September 24, 2001  
Contract No. NRC-02-97-009  
Account No. 20.01402.571

Subject: Submittal of report, "Effect of Environment on the Corrosion of Waste Package and Drip Shield Materials" (CNWRA 2001-03), Intermediate Milestone 01402.571.170

## RESPONSES TO NRC COMMENTS ON IM 01402.571.170

### **“EFFECT OF ENVIRONMENT ON THE CORROSION OF WASTE PACKAGE AND DRIP SHIELD MATERIALS”**

Figure 2-3. Relative humidity(RH) at saturation of an aqueous solution of  $\text{NaNO}_3$  and  $\text{NaCl}$  at  $25^\circ\text{C}$  (Ge et al., 1998) (MDRH = mutual deliquescence RH)

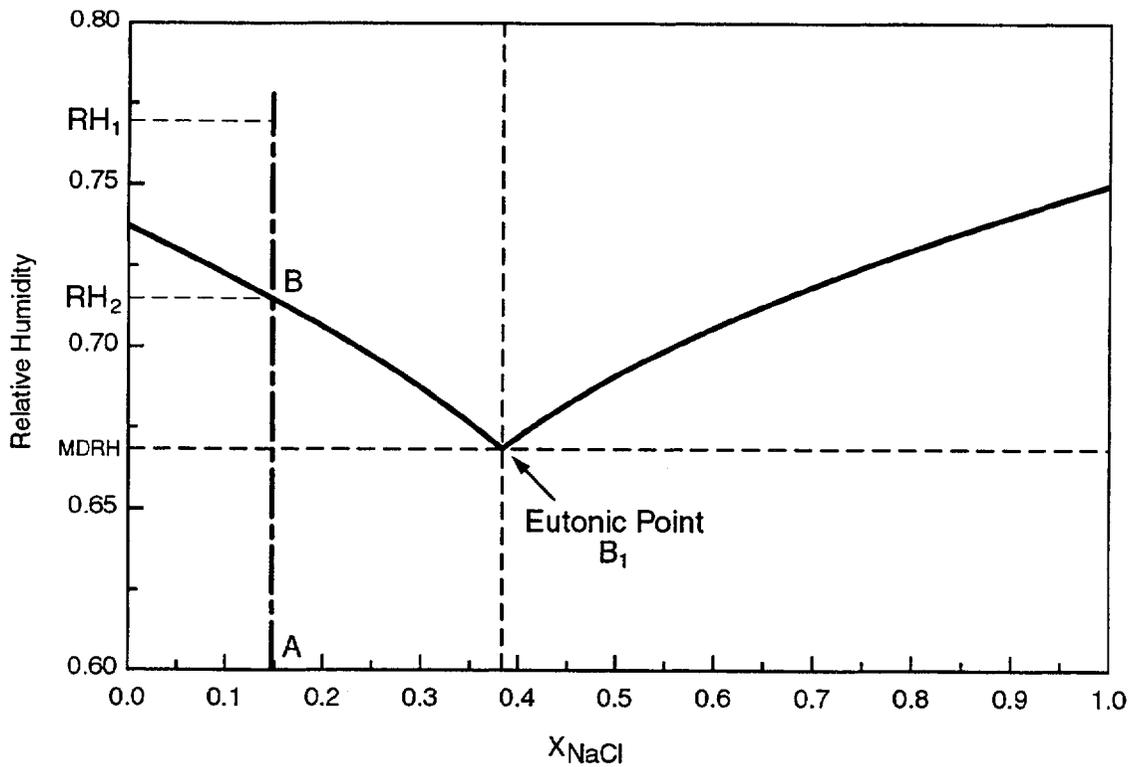
- 9. Discussion of Deliquescence Behavior is lacking fundamental explanation since solid sodium nitrate must be precipitating for the solution to become enriched in sodium chloride for the liquid to go from 15% sodium chloride at B to 38% sodium chloride at B1 in Figure 2-3. A solidus curve should be added to the figure to define the solid + liquid phase region.**

**Figure 3-5. U.S. Department of Energy predicted mean dose rate as a function of time for the basecase corrosion rate, and the 5<sup>th</sup> and 9<sup>th</sup> percentile median corrosion rates is fixed at the 5<sup>th</sup> and 95<sup>th</sup> percentile values of the uncertainty variance**

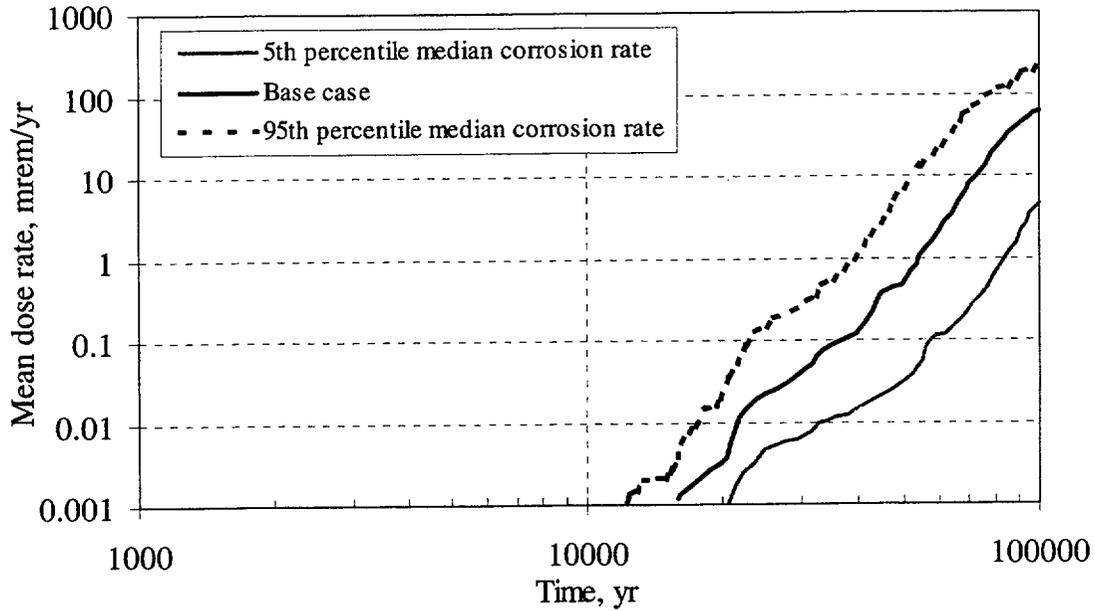
8. **Page 3-12. 2<sup>nd</sup> paragraph. Last sentence. “and the maximum dose rate at 100, 000 yr is  $2 \times 10^{-2}$  mrem/yr (figure 3-5).” That is 0.02 mrem/yr, not 200 mrem/yr as indicated in the figure. Should be  $2 \times 10^2$ , not  $10^{-2}$ .**

Accept, change made.

Figure 3-11. Metal ion concentrations measured using capillary electrophoresis from the anodic dissolution of Alloy 22 at 500 mV<sub>SCE</sub> in 0.028 M chloride at 95 °C

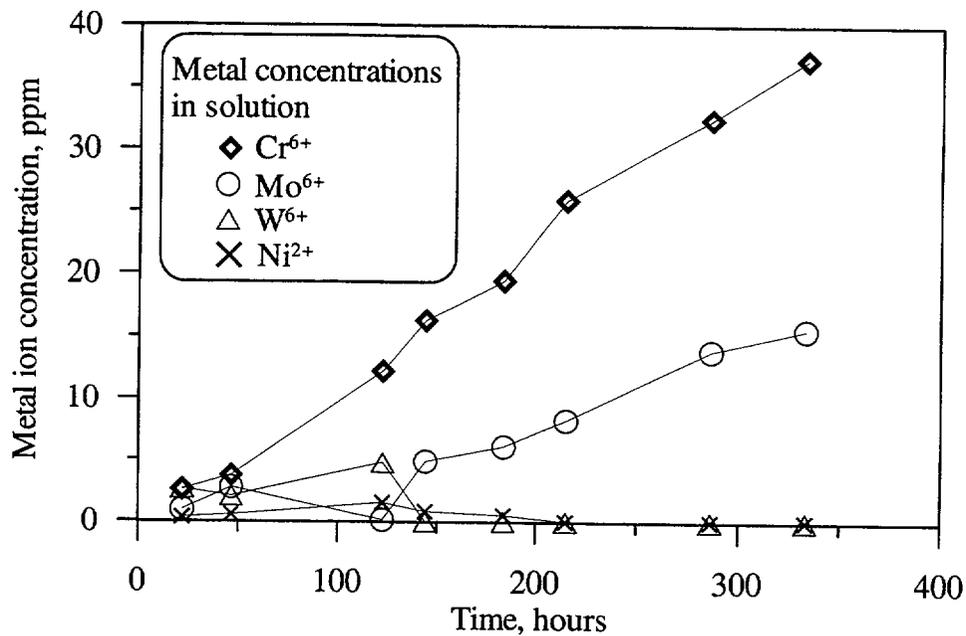
10. **Page 3-22. Figure 3-11. Graph label typo on X-axis.**

**Figure 4-5. Predicted drip shield failure times using WAPDEG for the basecase (mean), and enhanced (5<sup>th</sup> percentile) and degraded (95<sup>th</sup> percentile) drip shield cases (Civilian Radioactive Waste Management System Management and Operating Contractor, 2000h)**

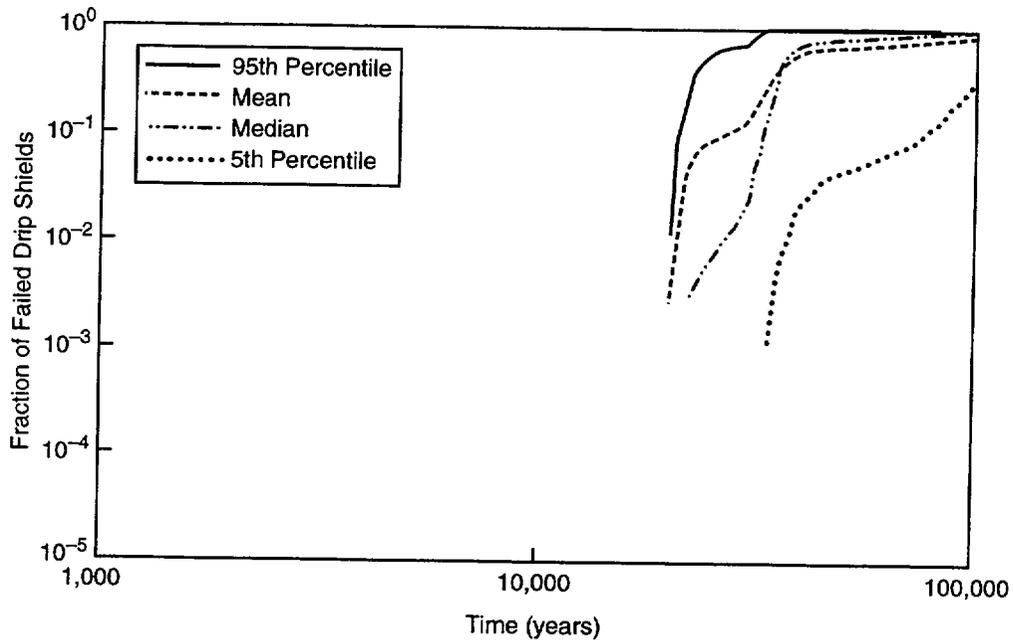
15. **Page 4-8. Figure 4-5. The graph cannot stand alone. The legend needs addition information. Suggest adding Degraded case to 95<sup>th</sup> percentile and Enhanced Case to 5<sup>th</sup> percentile. The chart is explained in the text, but the chart alone is insufficient.**

Accept. These are, however, DOE figures and we should be careful about altering them. Consequently, no change to the figure was made but the figure caption was modified to help clarify.

Figure 4-9. Effect of fluoride on the passive current density for Ti Grade 7 over time in a deaerated, 1 M NaCl solution at  $95^\circ\text{C}$  and an applied potential of  $0 \text{ V}_{\text{SCE}}$

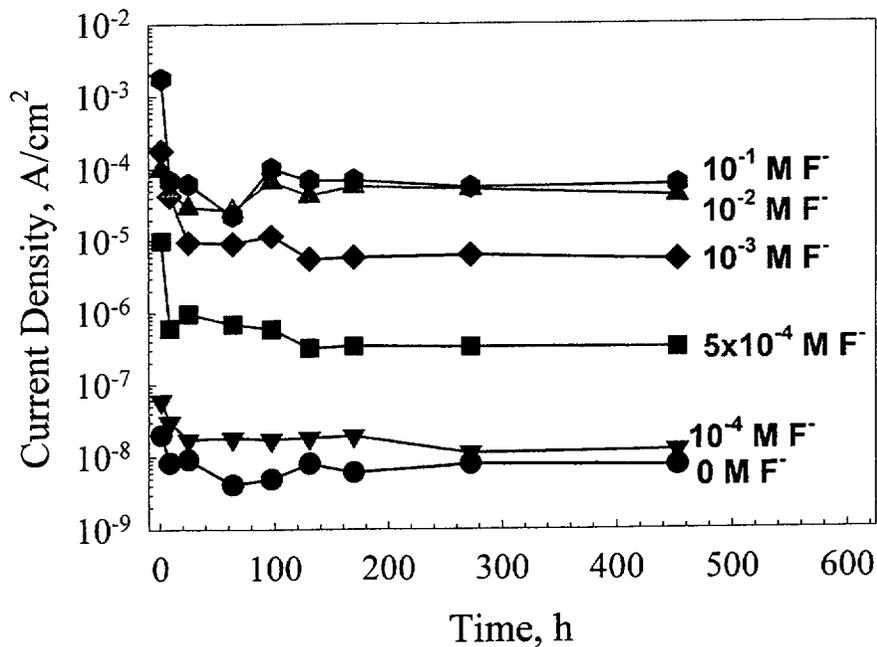
16. **Page 4-12. 1<sup>st</sup> paragraph, 2<sup>nd</sup> line. The plateau is at  $10^{-2}$  or  $10^{-1}$ ? It looks like  $10^{-1}$  from the graph (figure 4-9), but I am not certain.**

The difference between  $10^{-2}$  and  $10^{-1}$  is relatively small and the rate of change is decreasing sharply between these concentrations. Thus, even though a slight increase in the passive current density was observed when the fluoride concentration was increased from  $10^{-1}$  to  $10^{-2}$  it seems more likely that the start of the plateau is at or very near  $10^{-1}$ .

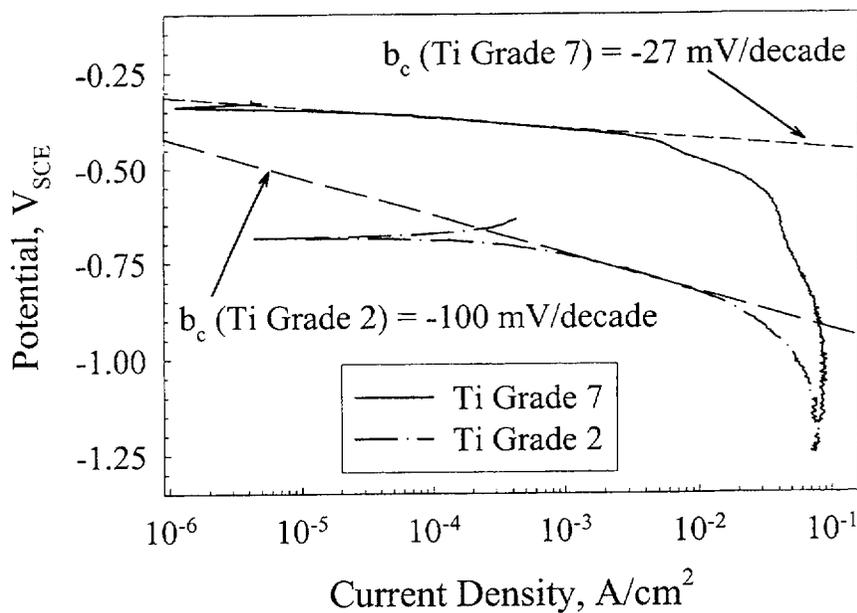
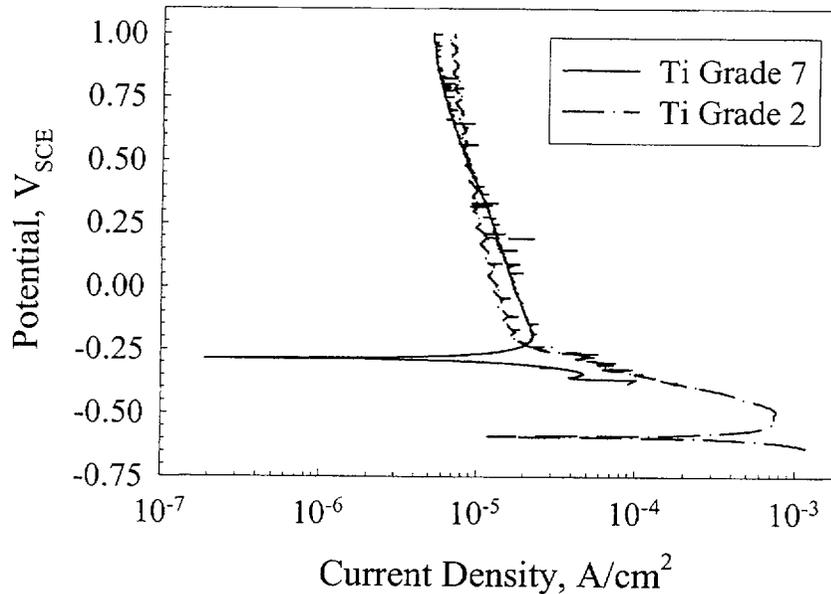
31. **Page 4-19 Numbering problem -- Figures 4-19 and 4-20, not 4-18 and 4-19 (also page 4-20, Figure 4-19, not 4-18).**

Accept.
